**Addendum No. 1
BL162-23
Harris Elementary School Fire Flow Improvements**

The following addition/changes modify the Bid No. BL162-23 "Harris Elementary School Fire Flow Improvements" Contract Documents, dated November, 2023, as first advertised on November 08, 2023.

Harris Elementary School Fire Flow Improvements

CD.01

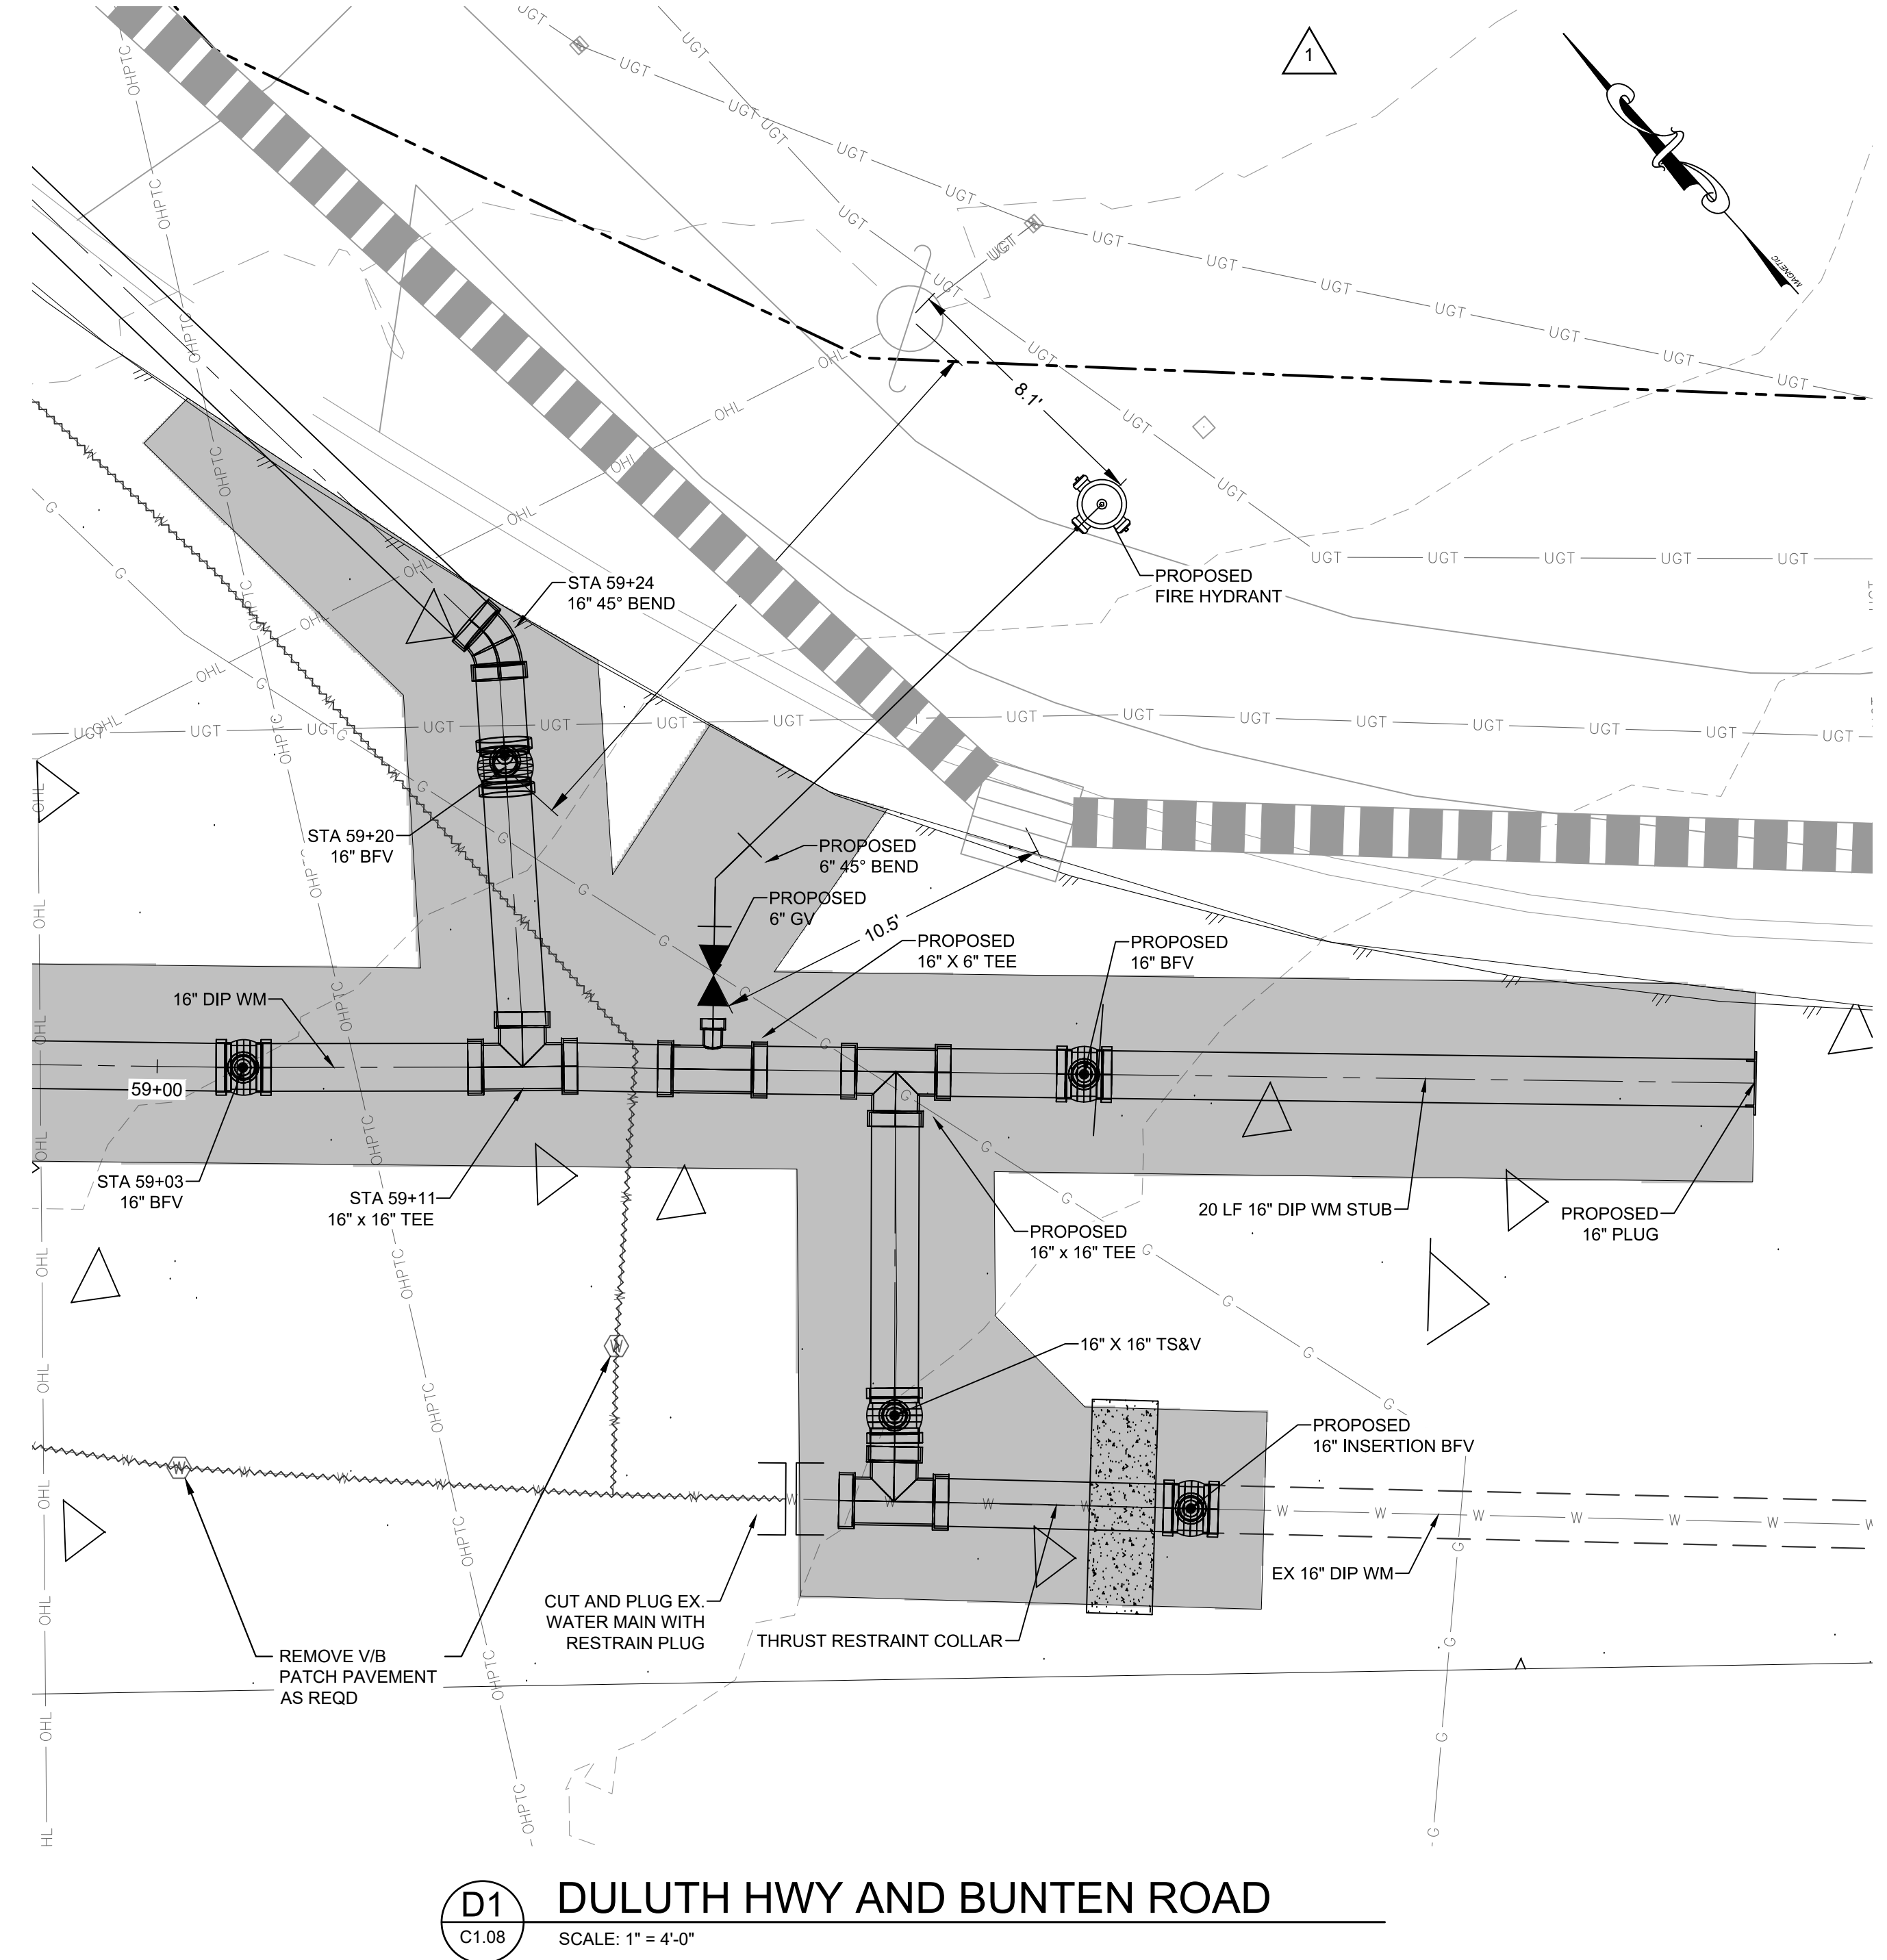
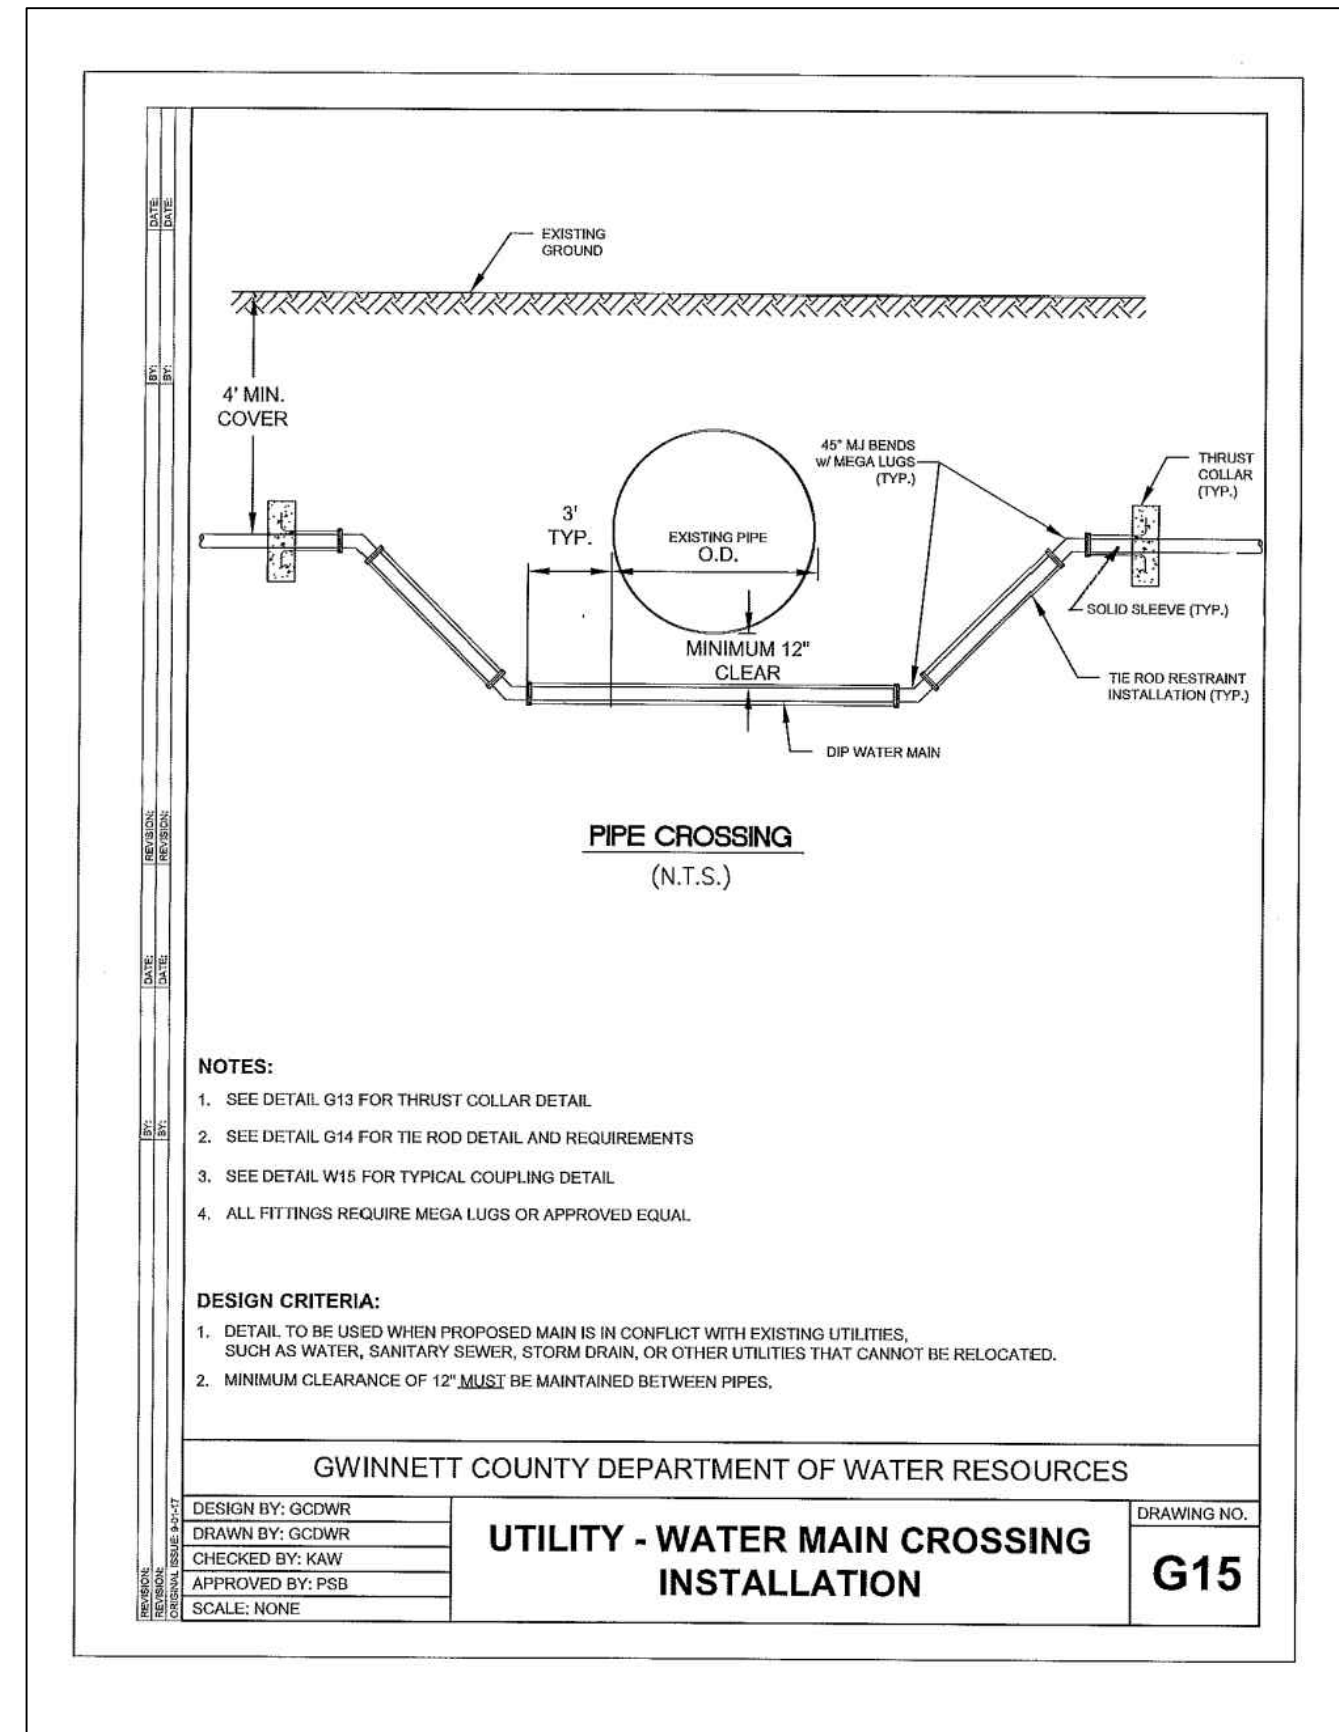
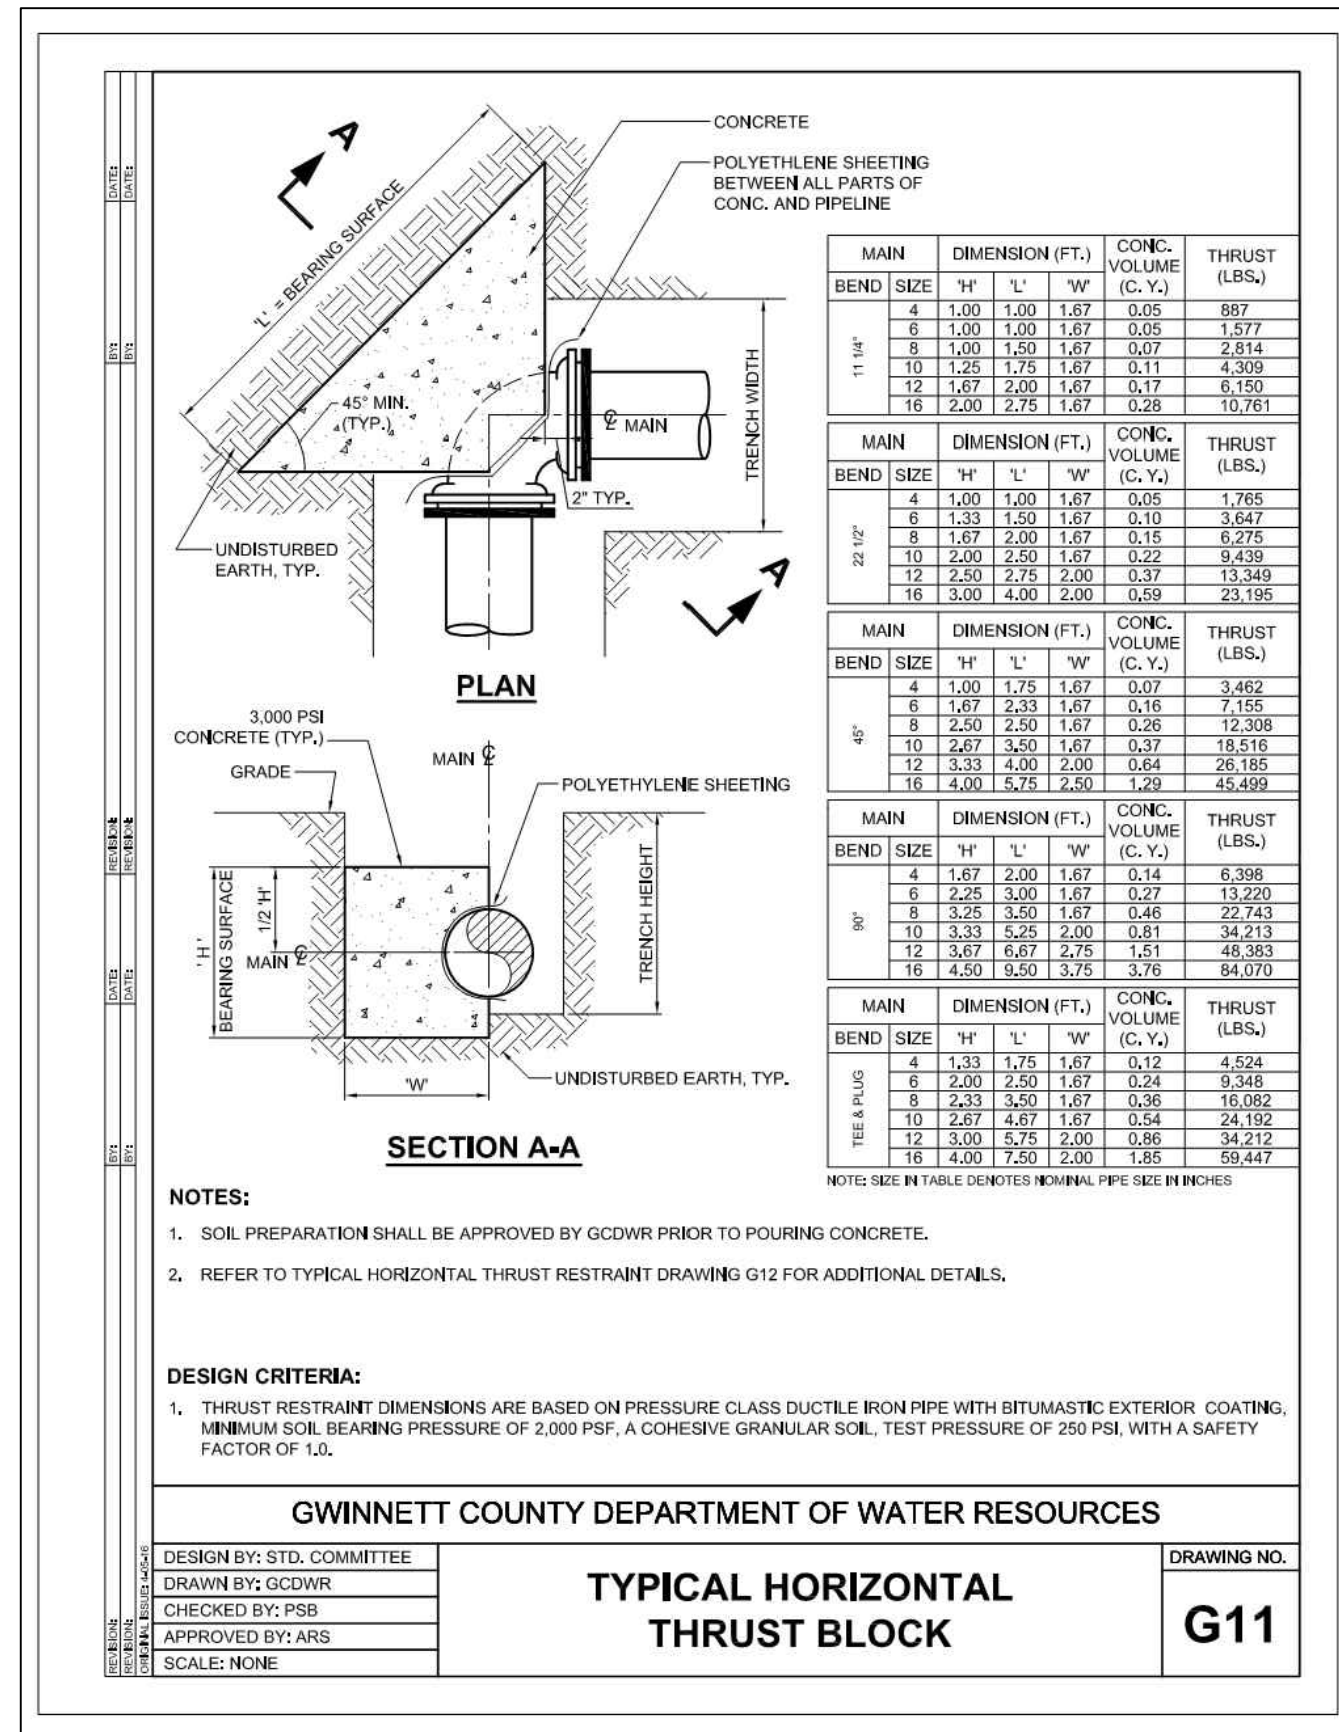
- Q12. Can a list of plan-holders be provided?
A12. The plan holders list is available at bidding.bargedesign.com.
- Q13. Sheet CD.01 shows a 16" insertion butterfly valve. Is this the 16" temporary line stop valve described in 33 12 16, 2.5 and Bid Item #35, or are we to quote a permanent insertion type valve per 33 12 16, 2.6?
A13. Provide insertion valve per Specification Section 33 12 16 Paragraph 2.6.

3. Drawing CD.01, Detail D1/C1.05 Titled "Duluth Hwy and Bunten Road"
ADD the following Note 1: "The Contractor shall pressure test against the 16" tapping valve at the connection to the existing 16" CIP water main. The 16" Insertion valve shall be installed to limit the impacts of the shutdown when the adjacent cut and plug is performed but shall not be tested against".
